Shenzhen Ulanzi Technology Co.,Ltd.

Ref: FCC Class II Permissive change for FCC ID: 2BGZ6-A100

This is to request a Class II Permissive change for FCC ID: 2BGZ6-A100 originally granted on 07/31/2024.

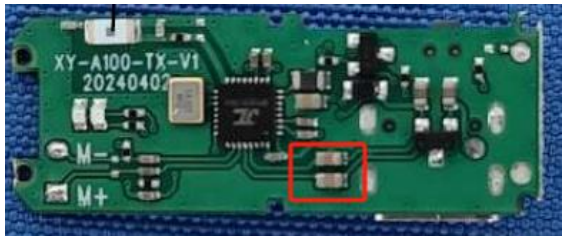
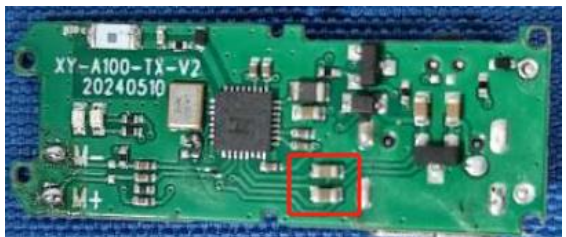
The change under this application is the original series model A300 was replaced by A30. The color of appearance and model name of series models listed are different from the main model, but the circuit and the electronic construction are the same, The A30 only changed the supplier of the capacitor CC4 and CC5 of on the substrate.

Supplier	specification	Photos
Original	Dongguan Zhengming Packing Products Co. , Ltd.	105Pf, 6.3V 0603	
New	Shenzhen Ulanzi Technology Co.,Ltd.	105Pf, 6.3V 0603
